1966 Corvette: Engineering Service Letter: RPO K-66 Wiring Diagram for Breakerless Ignition System

Subject: RPO K-66 Wiring Diagram for Breakerless Ignition System
Model and Year: 1966 Chevroleto, Chevelle, Chevy II, and Corvette with RPO K66
Source: Chevrolet Engineering Service Bulletin
Bulletin No: TSB #11
Section: NA
Date: November 11, 1965

1966 CHEVROLET, CHEVY II & CHEVELLE

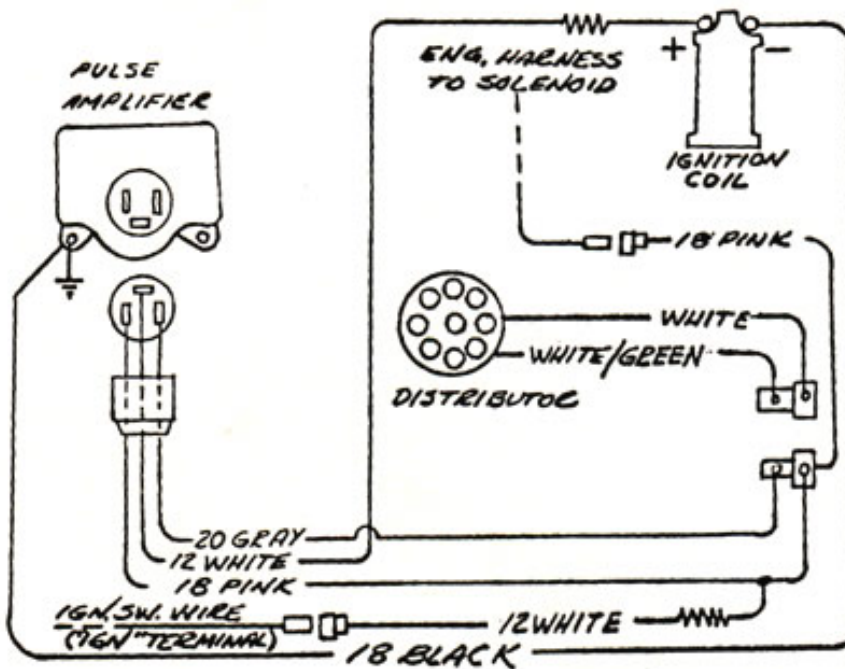
With reference to the 1966 Passenger Car Chassis Service Manual, Section 6Y-15, the wiring diagram of Figure 3.i requires clarification. The diagram on the left side of Figure 3.i should be titled "Chevrolet, Chevy II, and Chevelle" and the right side diagram should be titled "Corvette" (see attached.)

On the Corvette diagram, the "12 white" wire and the "20 black" wire from the negative ignition coil terminal to ground on the pulse amplifier should be an "18 black" wire for its entire length. The "12 white" is a calibrated resistance wire and is located on the negative side of the ignition coil on 1965

vehicles. However, in 1966 this resistance was placed on the positive side of the coil for added protection of the pulse amplifier in the event of accidentally grounding the ignition coil wire. This change has been incorporated in the passenger car models only.

The pulse amplifier in the left side view of the figure should reflect that the unit is grounded.
